Contract No. T201804301.01
Federal Aid Project No. NH-S018(18)
Georgetown East Gateway Improvements
Sussex County

Enclosed is Addendum No. 2 for the referenced contract consisting of the following:

HV-04
SECTION
WRA
SHEET NO.
19

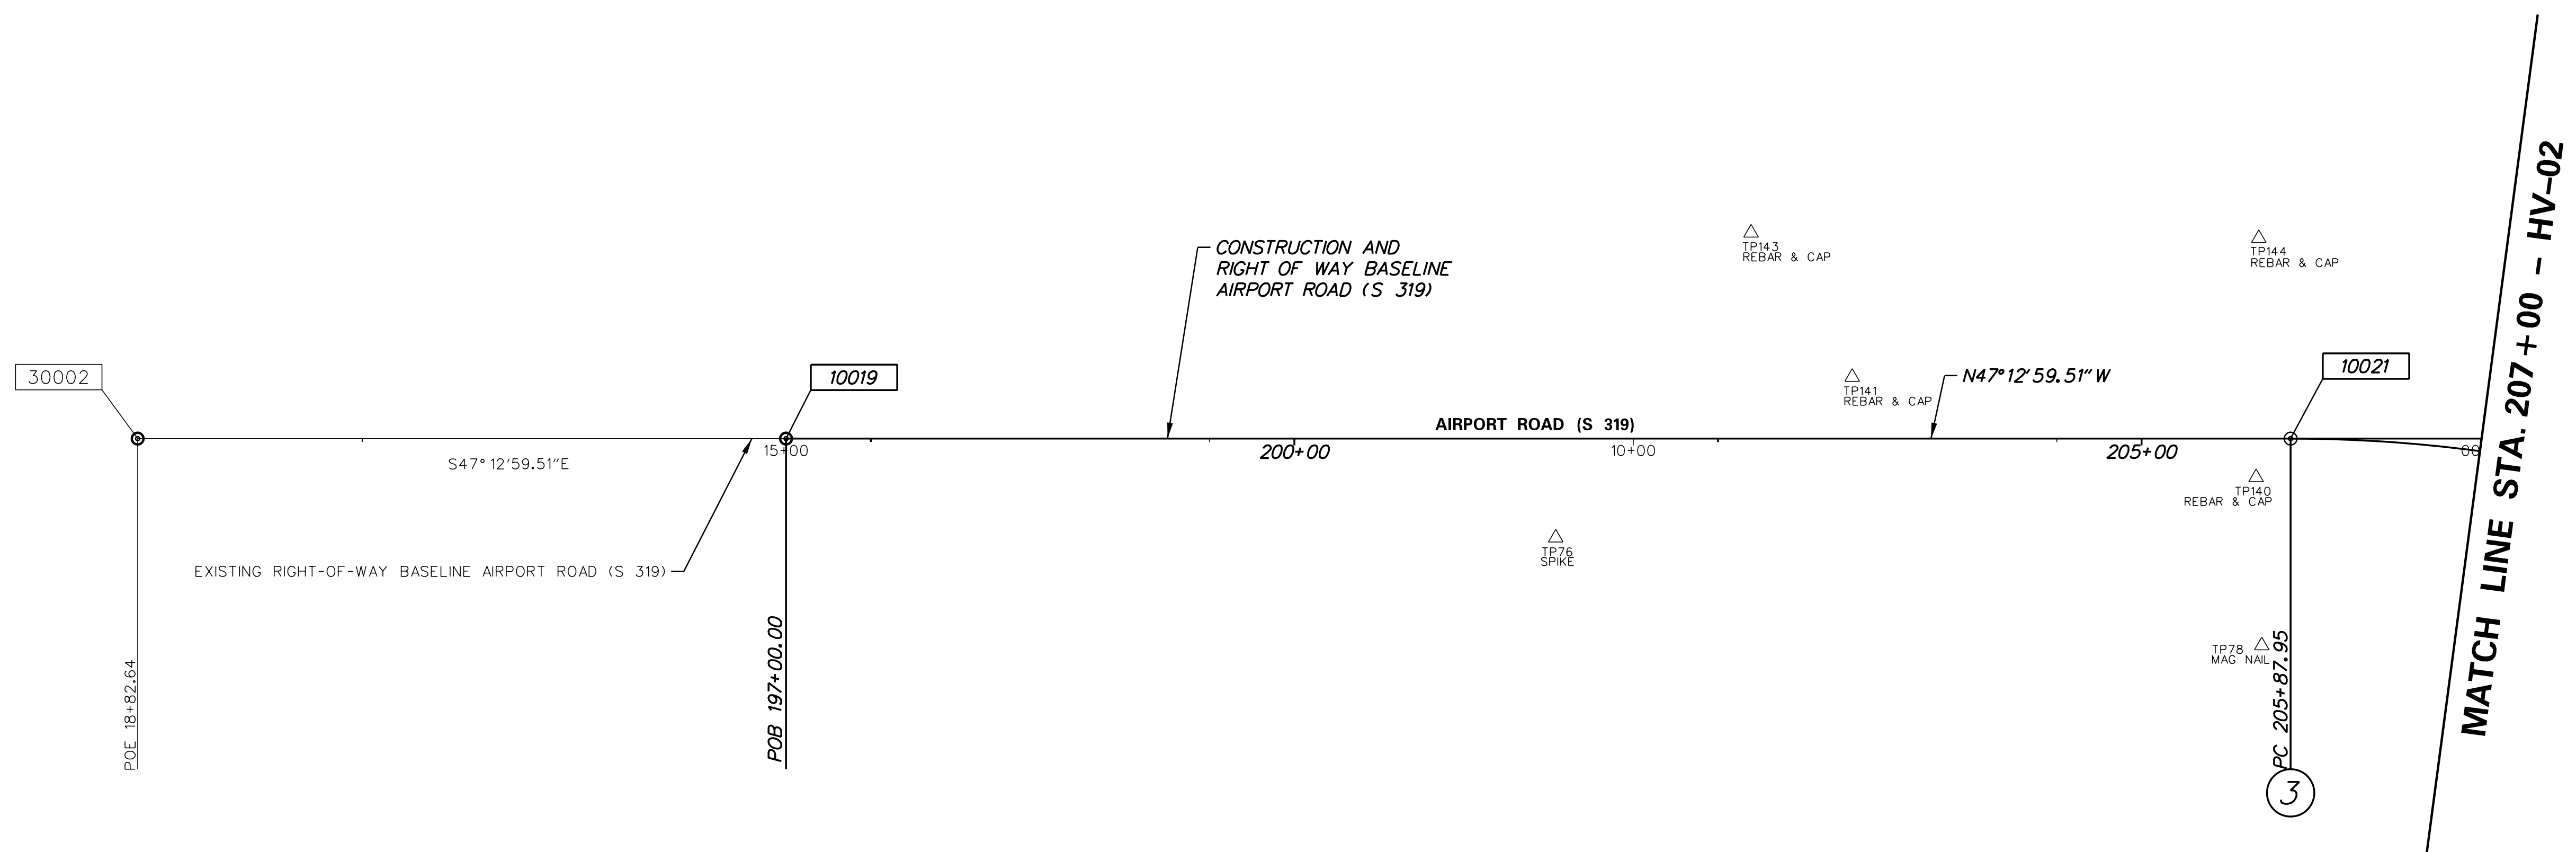
DATUM REFERENCE:
 HORIZONTAL - THIS PROJECT IS REFERENCED TO THE DELAWARE STATE PLANE COORDINATE SYSTEM ~~NAD 83/91~~; (NAD 83/2011).
 VERTICAL - THIS PROJECT IS REFERENCED TO NAVD 88.

CP-02
SECTION
WRA
SHEET NO.
23

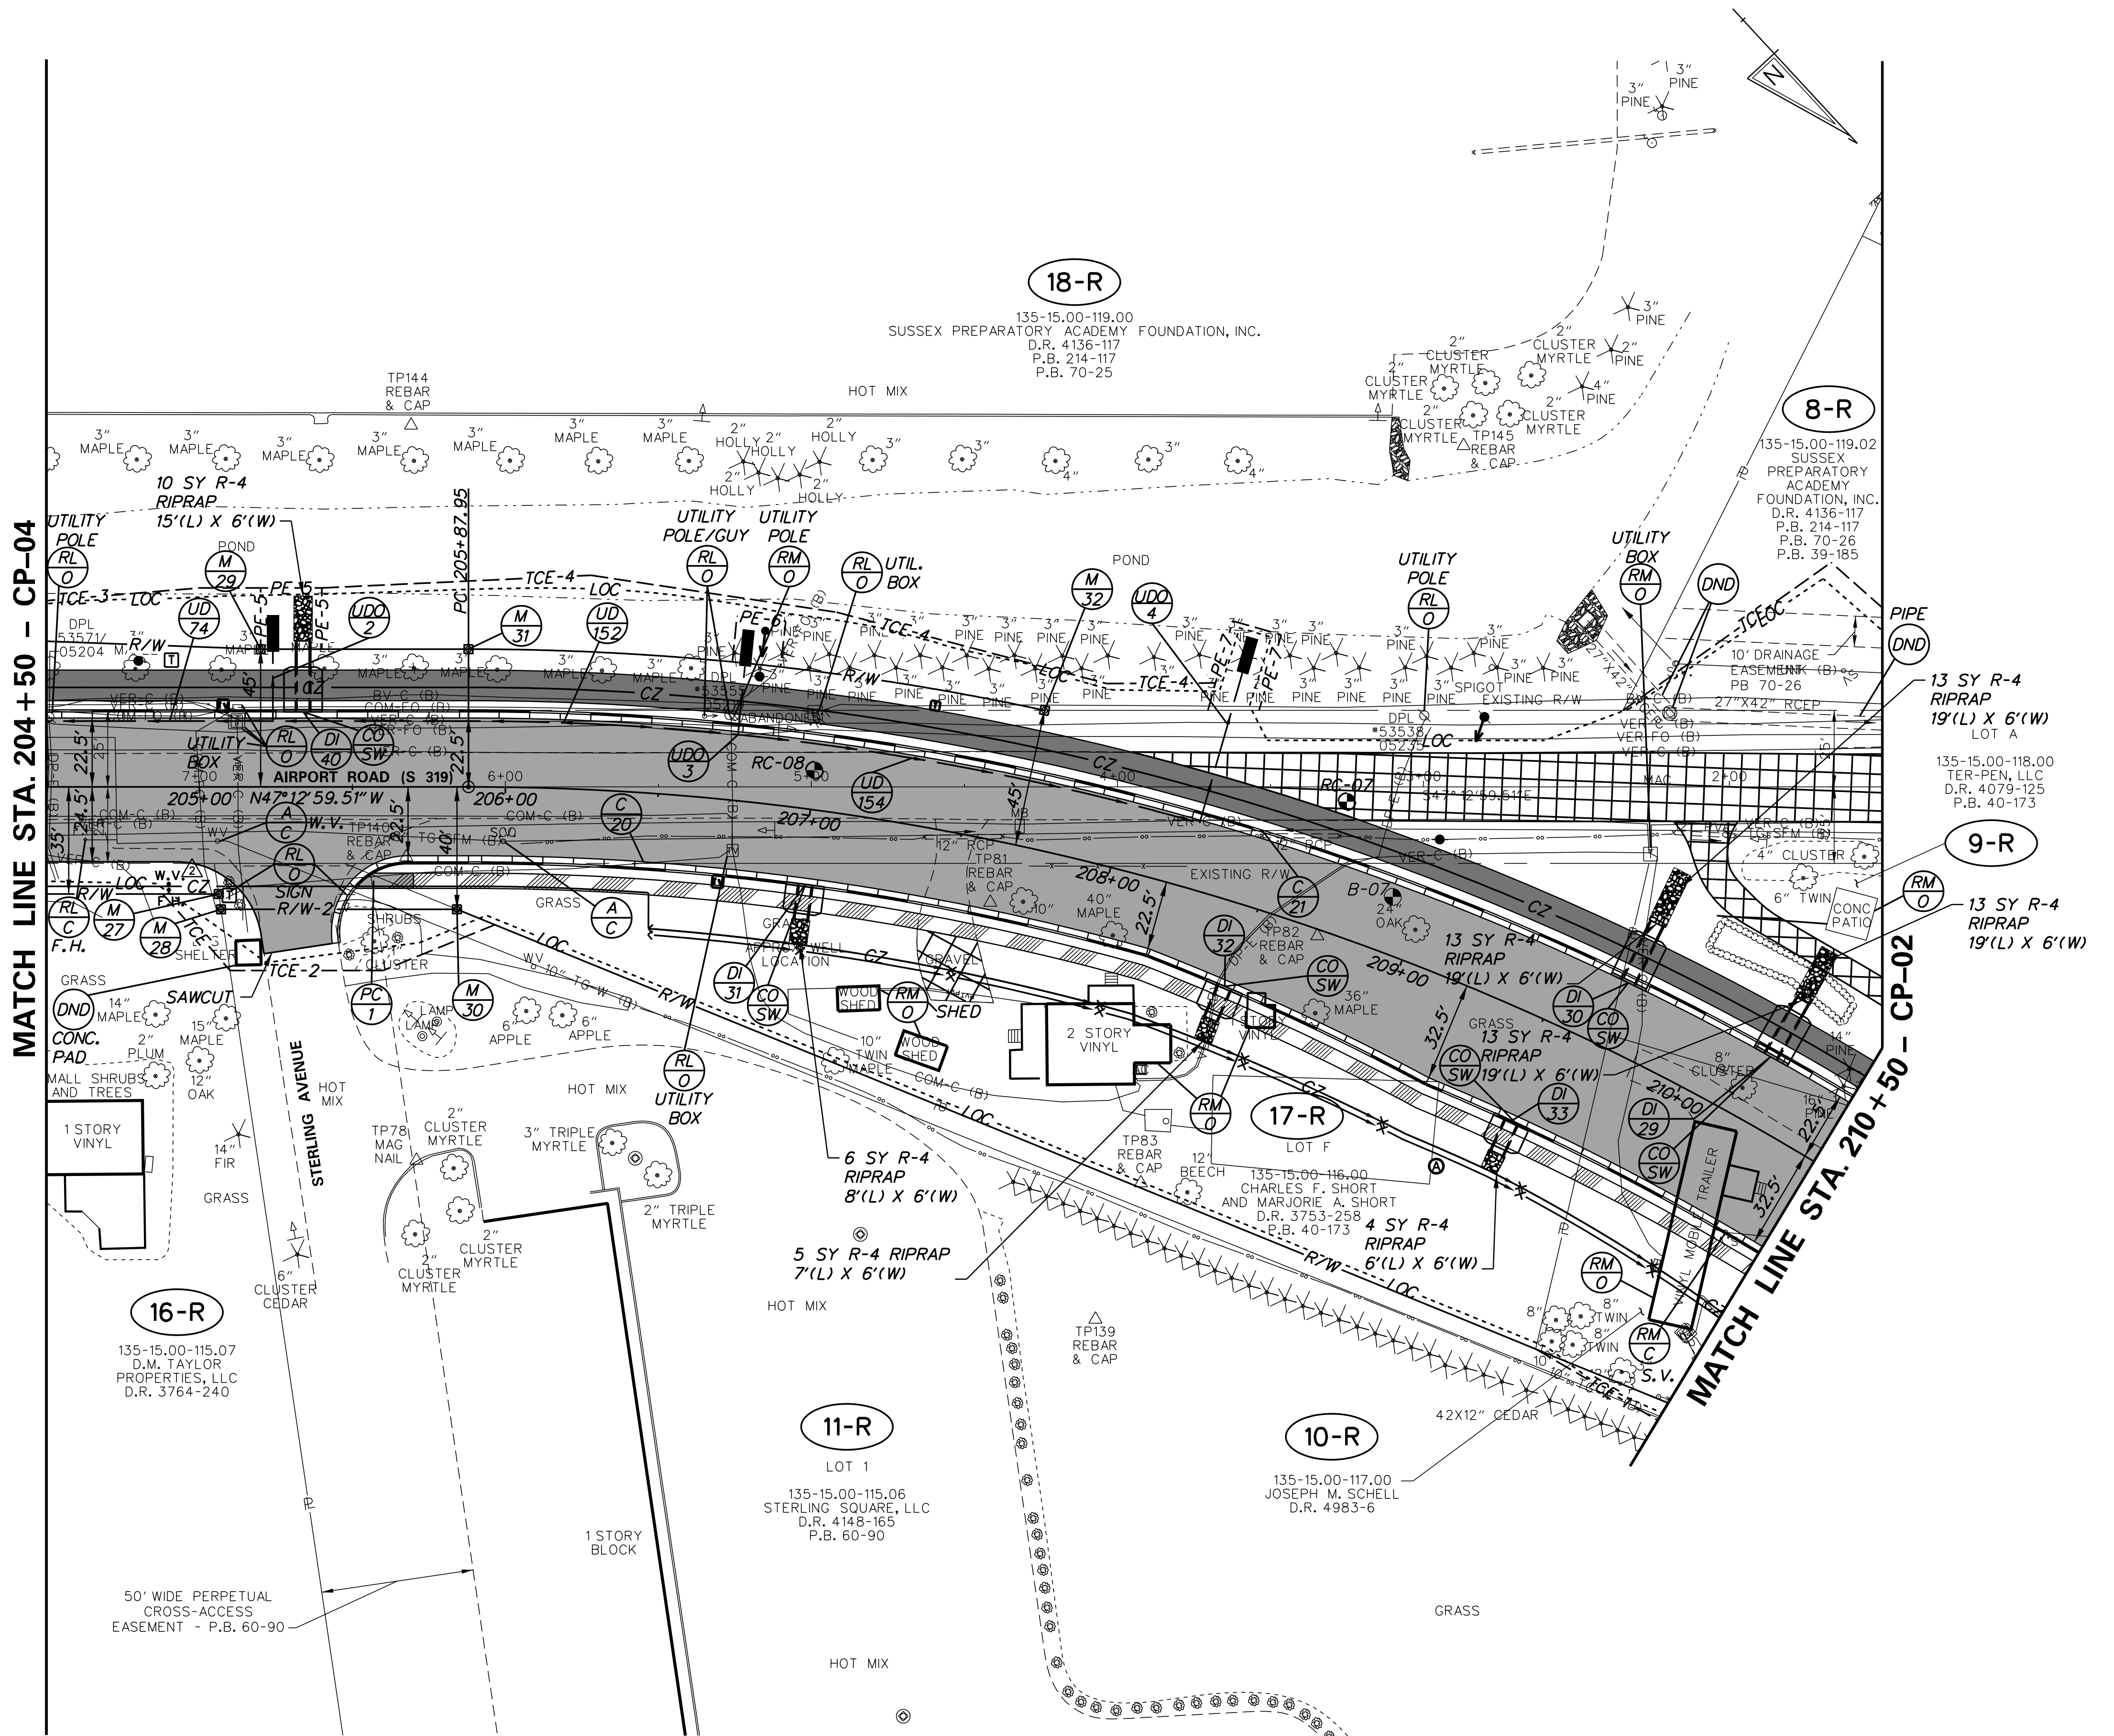
ADDED FIRE HYDRANT AND WATER VALVE. R. WILLS - 5/1/20		SCALE 0 30 60 90 FEET		GEORGETOWN EAST GATEWAY IMPROVEMENTS		CONTRACT T201804301		BRIDGE NO. 		CONSTRUCTION PLAN	
						COUNTY SUSSEX		DESIGNED BY: JAD CHECKED BY: RRW

NOTES:
 1. SEE SHEET CP-10 FOR SCHEDULES.
 2. CONSTRUCT DOWNSPOUT DRAIN, SEE DETAIL ON SHEET DT-05.

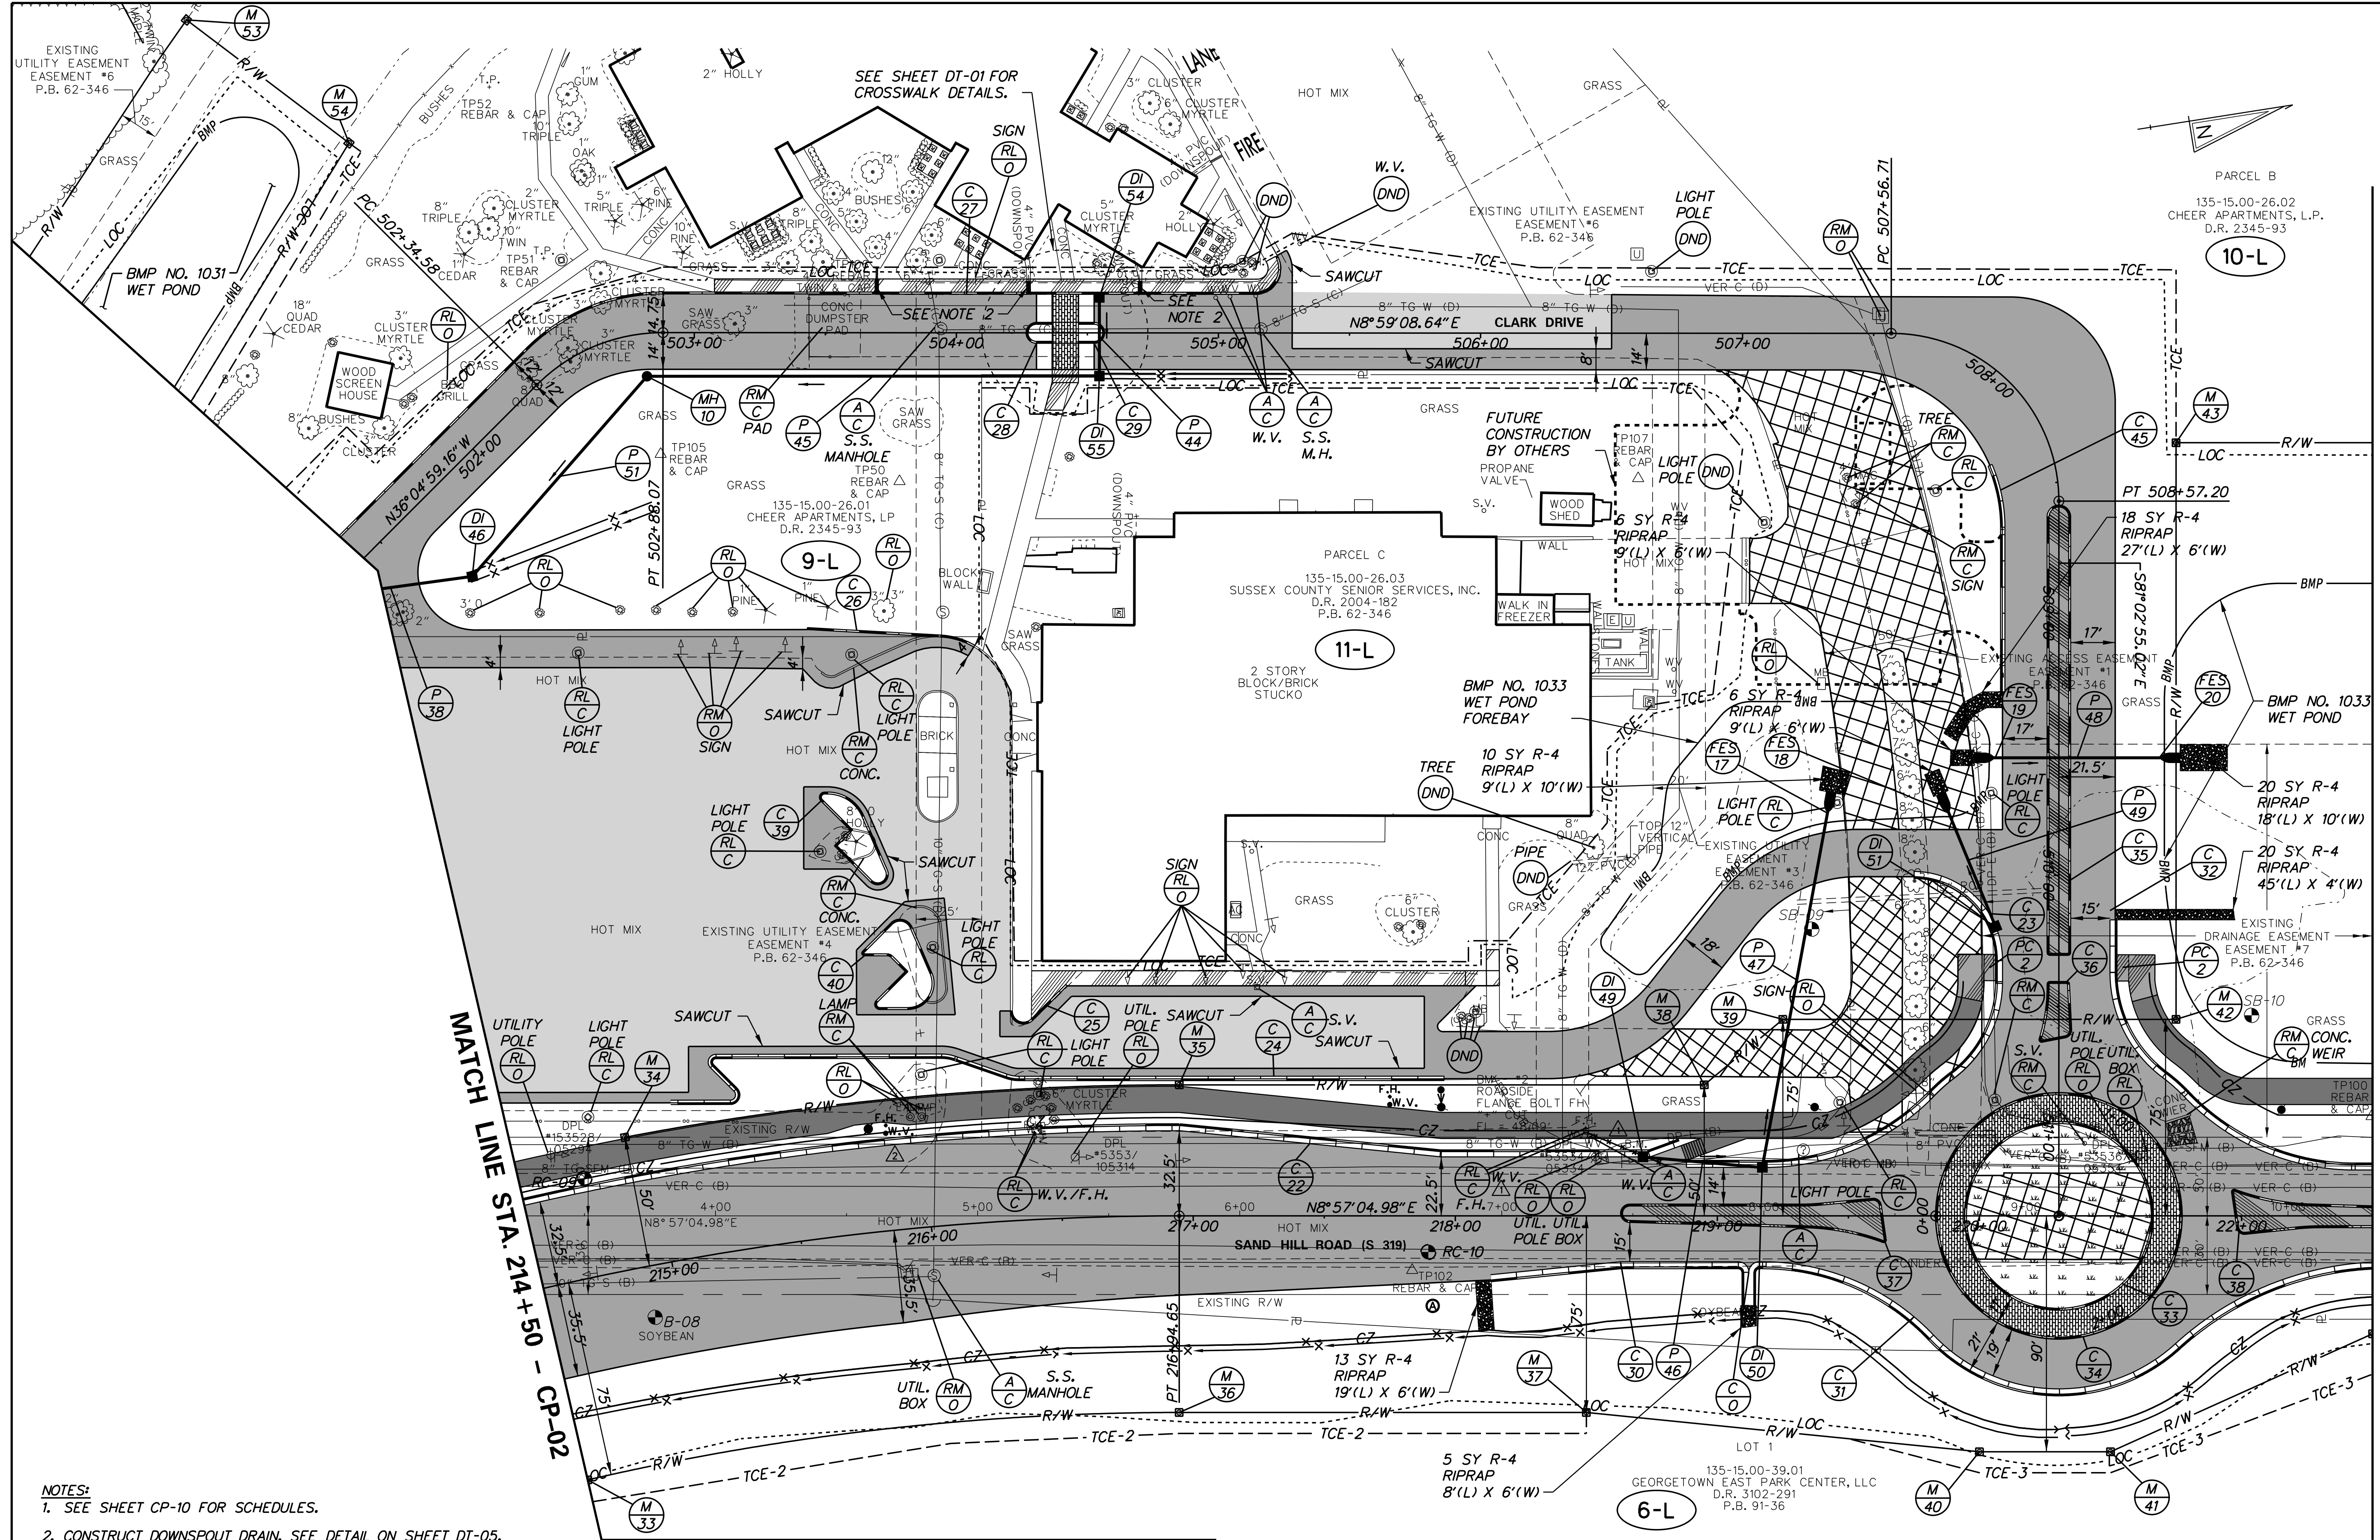
ADDED FIRE HYDRANT AND WATER VALVE, R. WILLS - 5/1/20
